Your Ref
EG/66/18/HH
Our Ref
PLAN-024956
Date
07/11/2018

Proposal: Single storey front extension & 1 No. new window to west ground floor elevation.
Site: Flintstones, Barnham Road, Eastergate, PO20 3RT.
EG/66/18/HH

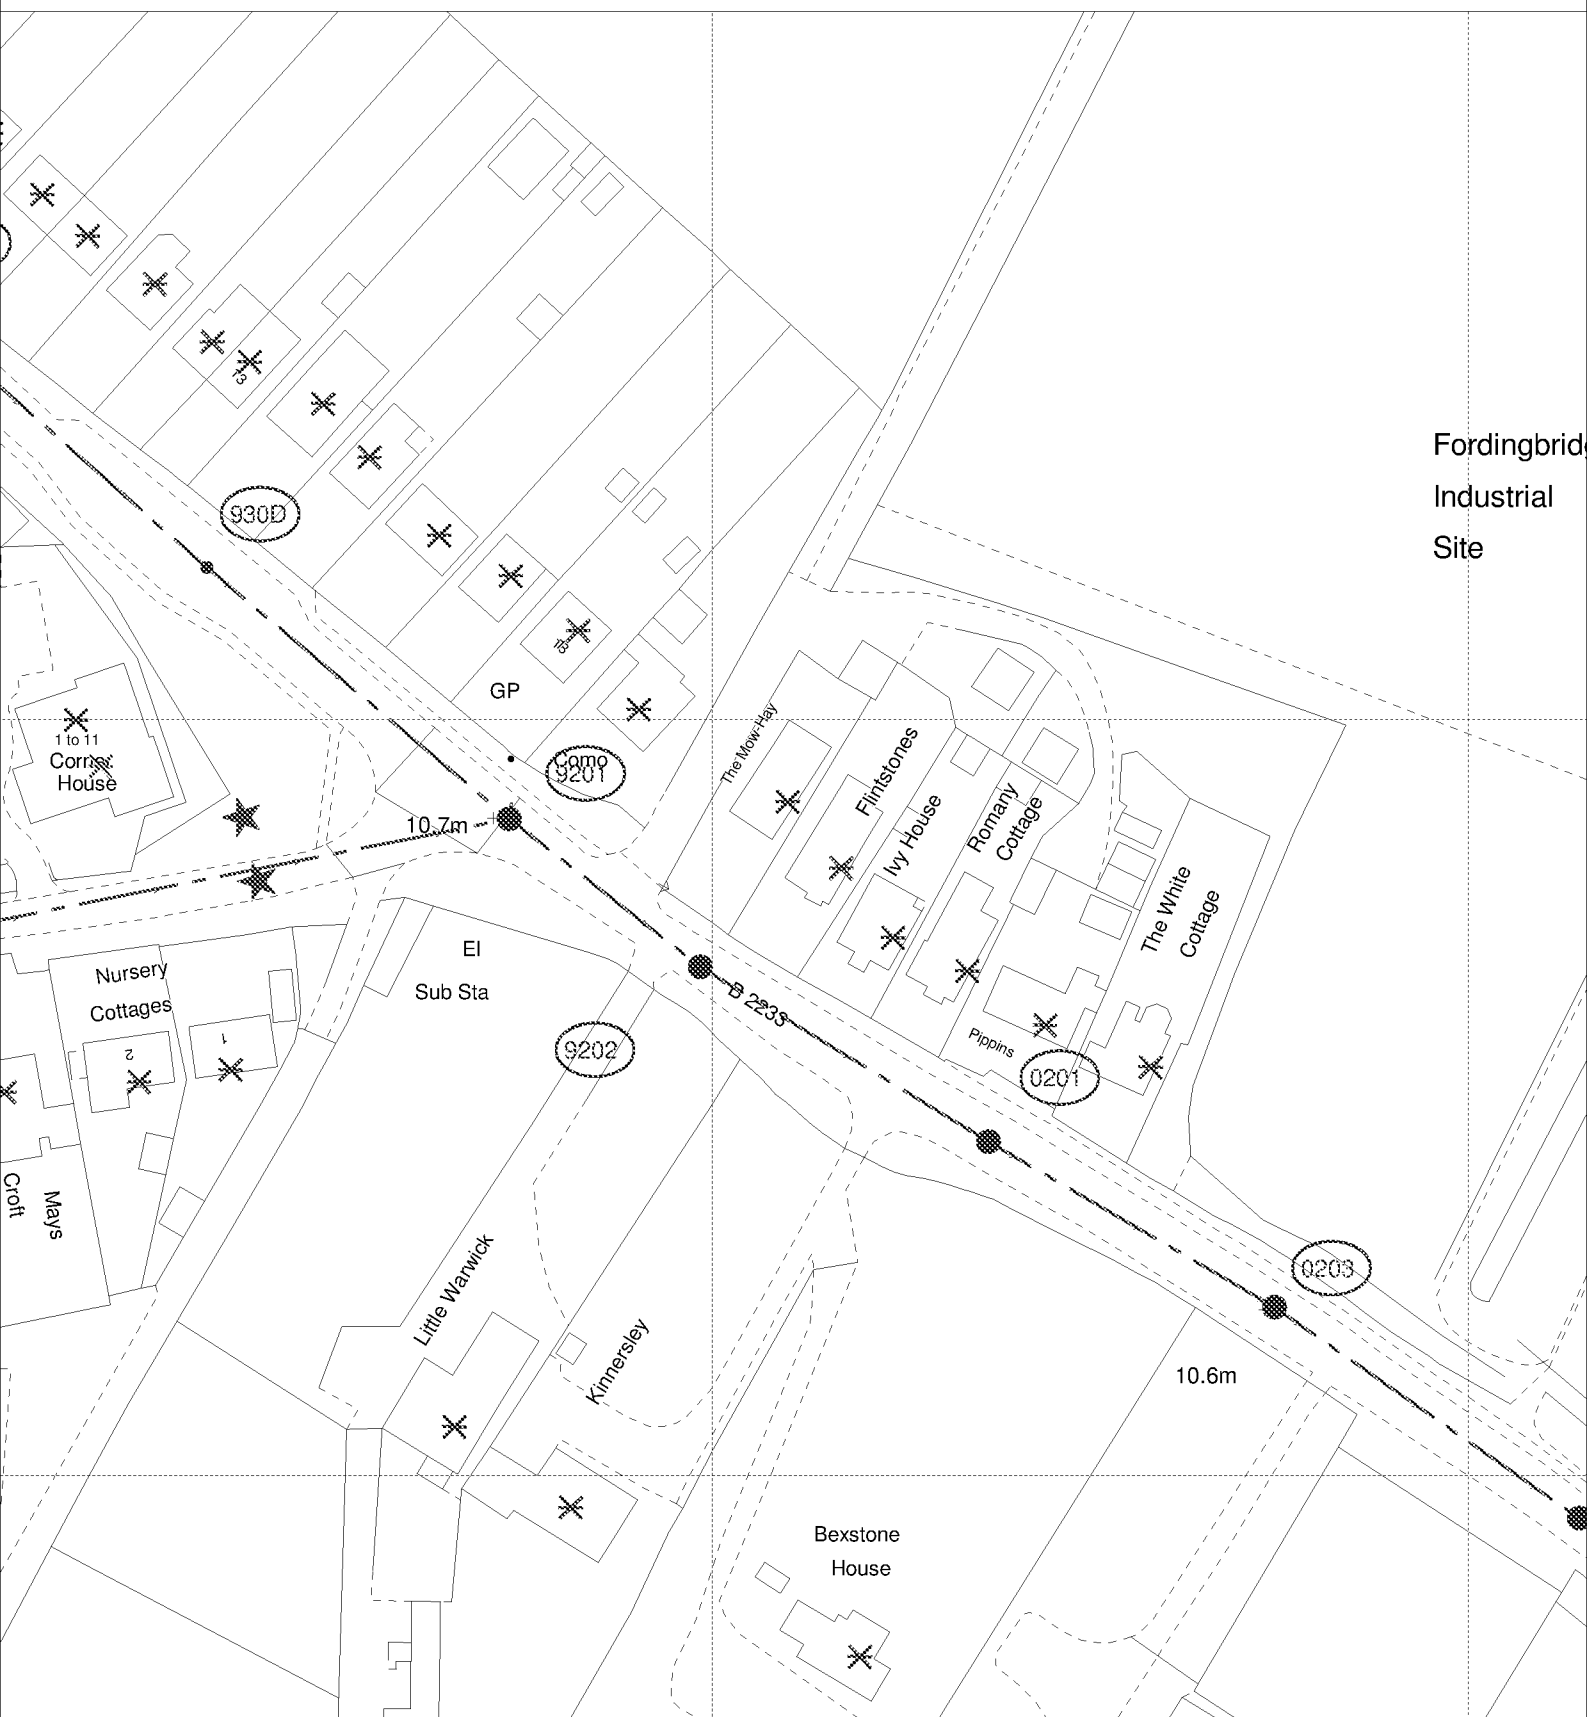
Our initial investigations indicate that there are no public surface water sewers in the area to serve this development. Alternative means of draining surface water from this development are required. This should not involve disposal to a public foul sewer.

Due to changes in legislation that came in to force on 1st October 2011 regarding the future ownership of sewers it is possible that a sewer now deemed to be public could be crossing the above property. Therefore, should any sewer be found during construction works, an investigation of the sewer will be required to ascertain its condition, the number of properties served, and potential means of access before any further works commence on site.

Developer should look to protect the public sewerage system from inundation and infiltration, which contribute to flooding in unfavourable conditions.
